CITY OF ISSAQUAH DEVELOPMENT SERVICES DEPARTMENT URBAN VILLAGE DEVELOPMENT COMMISSION

STAFF REPORT

File No.: SDP17-00002
Project: Issaquah Highlands

Westridge Townhomes - North - Site Development Permit

Top Pic(s): Example of Character Streets Bottom Pic(s): Street furnishing examples

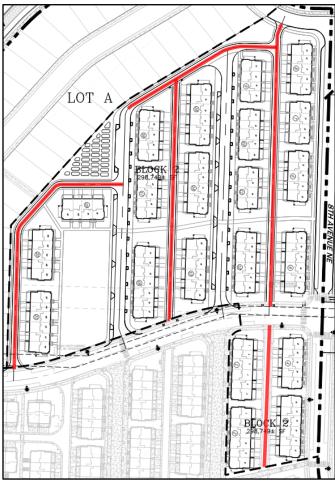
Character Streets feature a continuous surface throughout the paved portion of the corridor section, thus pedestrians and vehicle zones are defined by vertical elements such as bollards or raised planters and changes in paving materials, color, and/or texture, rather than use of vertical curbs. [Condition 22]

To create the character and convey the pedestrian priority of the space, Character Streets are constructed out of concrete or other non-asphalt paving. The traveling lanes will be 20-feet wide with a 7-feet lane for on-street parking on the west side. The east side of the road will be constructed to have a 5-foot wide planters or other vertical elements along with a 5-foot wide walkway. The west side of the street will provide a 5-wide walkway. A driveway cut must be applied when an alley connects to a Character Street. Where Character Streets intersect with a public road a street cut shall be used. The street design will be evaluated during the Site Work Permit review to determine the appropriate cut was installed. [Condition 23]

The following pictorial examples demonstrate the intended design characteristics of the Character Streets, though the ARC will also review for these design characteristics:

- The Character Streets shall be designed using vertical elements (e.g., planter, bollards, street lights, etc., but not curbs as shown) and changes in the paving material (color and/or texture) to define the pedestrian and vehicle zones. Concrete or other non-asphalt paving materials must be used. A driveway cut must be applied when an alley connects to a Character Street. Where Character Streets intersect with a public road a street cut shall be used. Street designs and cuts will be reviewed at the time of the Site Work Permit.

Proposed Parking Exhibit

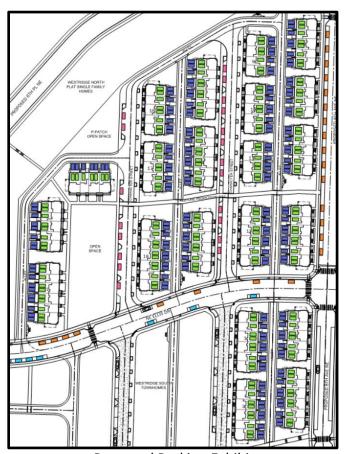
Required parking stall dimensions for on-street parallel parking is 7-feet x 20-feet and 9-feet x 18.5-feet for driveway and garage stalls. Generally, the stall dimensions appear to meet the requirements. Per Action Memo No. 07-14-97-01 LCS (Revised), driveways between 8-feet and 18-feet are not intended for parking because vehicles that attempt to park on the driveway will extend into the drive lane of the alley. In addition, the applicant is proposing concrete driveways for the residences. In order to differentiate the driveways from the alley edge, driveways should be designed so that they are visually distinctive from the alley, e.g., exposed aggregate, colored concrete as well as a distinctive score line. [Condition 31]

The Issaquah Highlands standards require one bike parking space for each 12 vehicle parking spaces provided. The current proposal will provide 418 parking stalls, which results in 35 required bicycle spaces on-site.

No locations or stall quantities for bicycle parking were identified. It is expected bicycle parking will be provided in each individual garage; however, there should be some public bike parking available at public spaces such as the open space area as shown on Sheet L1.03 of the plan drawings. Bicycle racks must be placed in a manner when they are fully loaded, the bikes are accessible and do not impact surrounding walkways and landscaping. Bicycle parking will be reviewed further with construction permits. [Condition 33]

- 33 The proposed project currently generates the need for 35 bike parking spaces. The number of required bike parking spaces may be modified based on the final parking count. Some bike racks shall be provided throughout the site in close proximity to areas they serve such as common spaces, trails, and visitors. The bike racks should be positioned to not block sidewalk, walkways, or entrances when full of bicycles. Final bike rack locations must be shown on Site Work or Landscape Permit.

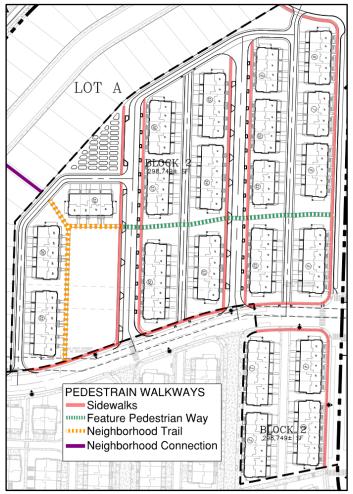
The proposal does identify a children's play area, though specific details are not provided. In order to provide opportunities for a wide age-range of children, the play area should be consistent with the generally formal structure of the Traditional Townscape Neighborhood Type while creating an area that would be interesting and inviting to children and adults. This could include rocks, paths, stepping stones, secret places, grade changes, water features, and outdoor artwork. These elements allow for more diverse and adventurous play, consistent with the neighborhood type's character while not precluding other residents from visually and physically enjoying the area. [Condition 53]

A joint ARC/City review of recreation and open space areas will occur with construction permits. If the IHCA maintains the space, they will have a say in what activities they will be accepted. See Appendix U: Parks, Plazas, and Woonerfs below for further discussion.

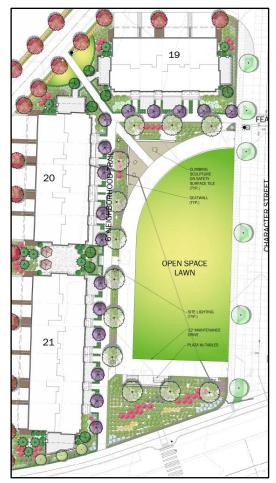
A Neighborhood Trail is a hard or soft surface trail designed to create recreational opportunities for pedestrians by providing connections between neighborhoods and land uses. Typically, Neighborhood Trails are meant to interconnect with the sidewalk system and should be located within or adjacent to neighborhoods, open spaces, or critical areas. The applicant is intending to have a Neighborhood Trail along the westside of the primary open space that then runs between Buildings 19-20 and connects to the alley behind Buildings 19-21. This segment of the trail also provides an opportunity to connect to the Westridge Single-Family Home project to the west. Please see image below.

The majority of the buildings throughout the complex face onto streets and receive their primary pedestrian access from the adjacent sidewalks, with the exception of buildings 20-21. These two units look onto the primary open space and therefore the Neighborhood Trail is the primary pedestrian access to these units.

The standard width of the Neighborhood Trail is 6-feet with a 4-foot landscape border on each side of the trail. The proposed design shows Building 19-21 having individual terraces for each unit that extend out toward the open space in an effort to create possible social interactions. Due to the size of the terraces, a 3-foot border on the west edge is provided instead of the 4-foot border. This design does not conform to the standard layout. The size of the terrace will need to be reduced or the trail location should be relocated. This will be reviewed in detail with construction permits. [Condition 54]
